# UT to Cane Creek Restoration Project Year 7 Final Monitoring Report

DMS Project ID Number – 95729, DEQ Contract No. 4951

Subject: Response letter to DMS review comments regarding the Draft Year 7 Monitoring Report for the UT to Cane Creek Restoration Project (#95729)  
Cape Fear Basin – CU#03030002, Alamance County, North Carolina  
Service Contract No. 004951, DMS No. 95729, RFP No. 16-004357, Baker No. 132700

**Current Condition  
Plan View - Figure 4A  
Monitoring Year 7  
UT to Cane Creek Site**

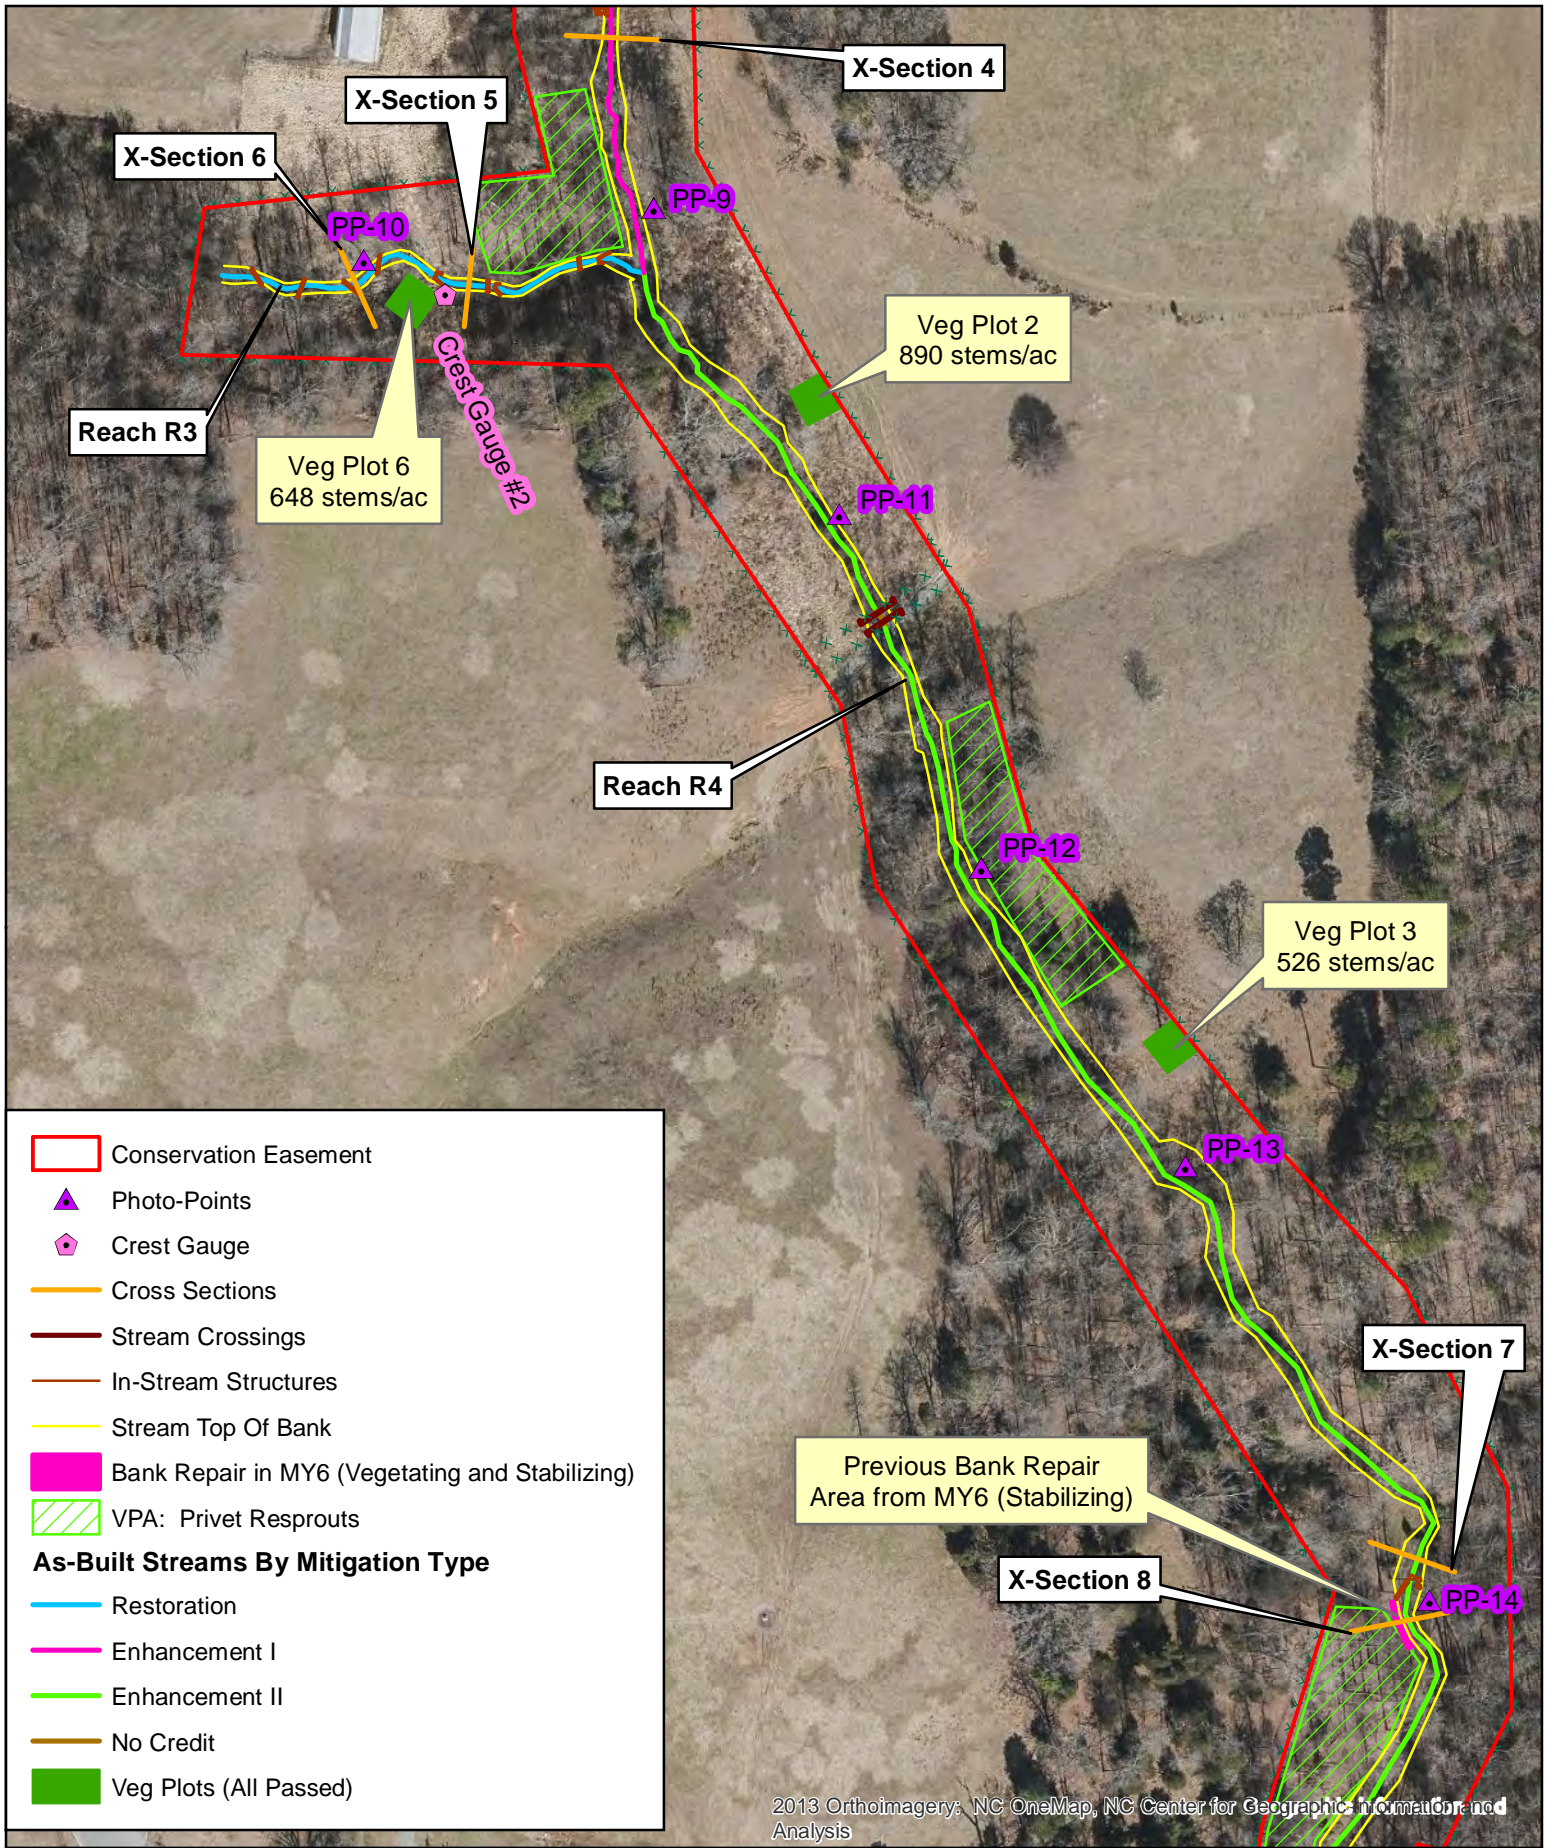
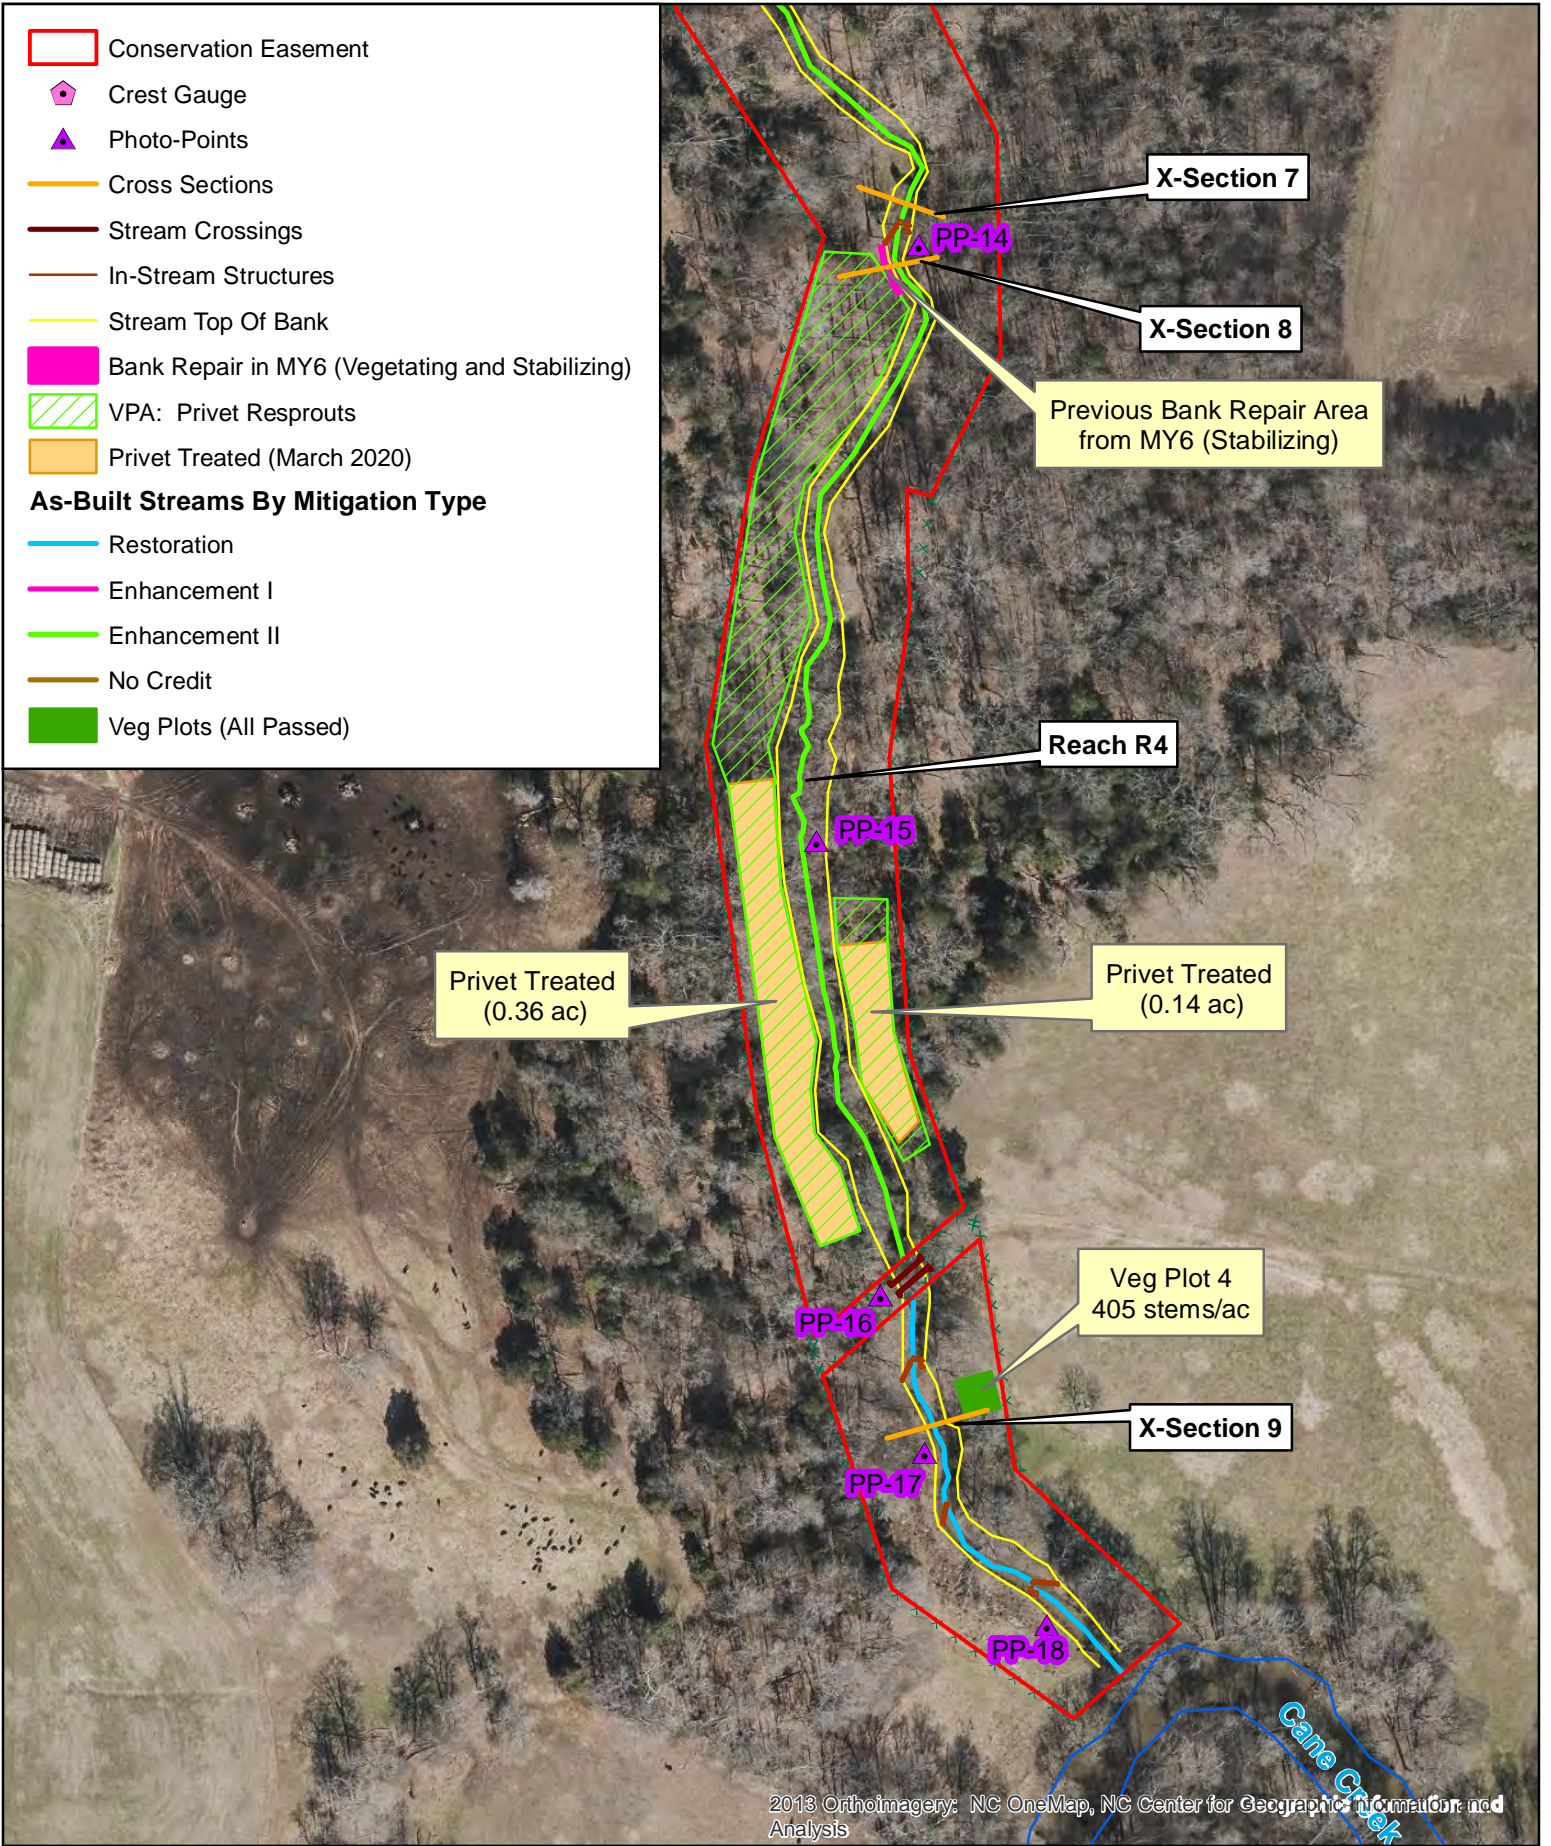
- a. Please include a photo point shapefile containing the spatial features that depict the photo points in the CCPV.

**Response: The photo-point location shapefile used in the CCPV has been provided with the revised digital submission files.**

## Permanent Cross-Section 4, Reach 5

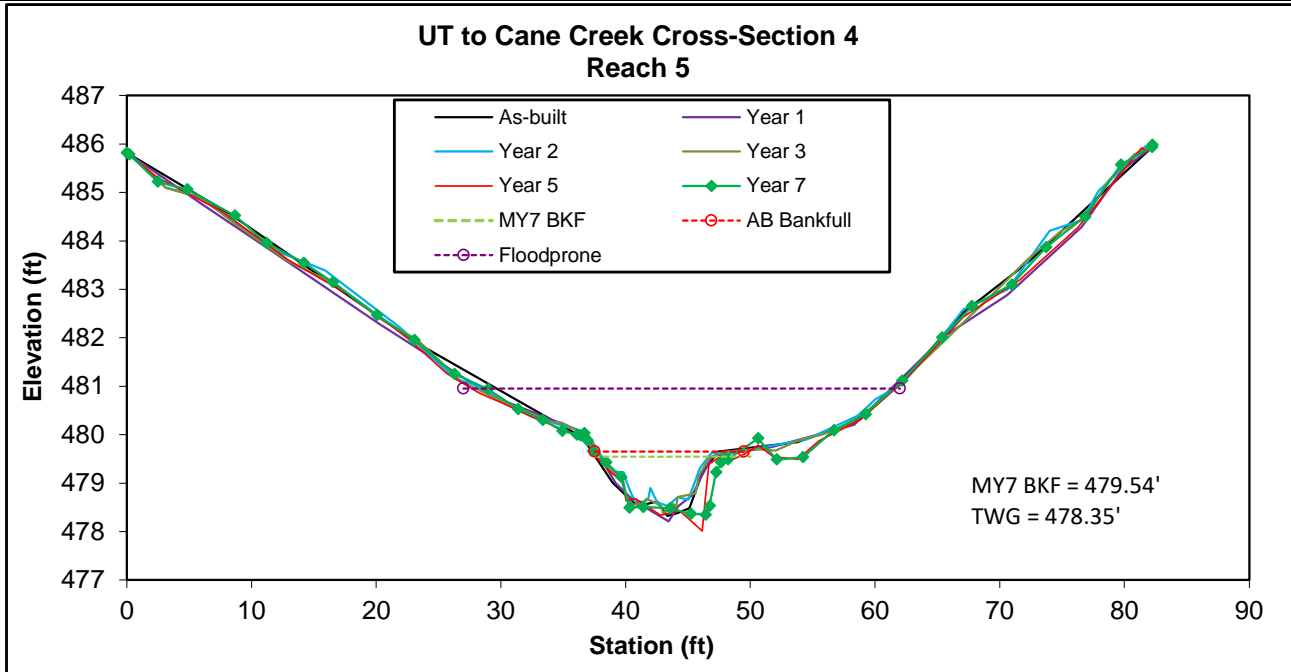
- c. Please verify bank height ratio calculations. Ensure that the elevation that achieves the MY0 bankfull area in the MY7 channel is being used in these calculations. For example: Cross Section 4 should have a BHR of 1.09, and should be using bankfull elevation of 479.54 to achieve the MY0 cross sectional area.

**Response: Baker checked each of the BHR calculations and verified that they are all correct with the exception of XS-4 as noted. The bankfull elevation derived from the as-built area for XS-4 was determined to be 479.54' (as noted) using the Mecklenburg spreadsheet and was used to determine the BHR shown, but just wasn't correctly brought into the project cross-section figure. However, using this elevation provides a BHR of 0.97, which rounds to the 1.0 shown in the cross-section tables. For clarity, the calculation was made using the following elevations (as provided in the XS-4 figure) and equation:**

$$\text{BHR} = (\text{Low bank elevation} - \text{TWG elevation}) / (\text{MY7 Bkf elevation} - \text{TWG elevation})$$
$$\text{BHR} = (479.51' - 478.35') / (479.54' - 478.35') = 1.16 / 1.19 = 0.97$$
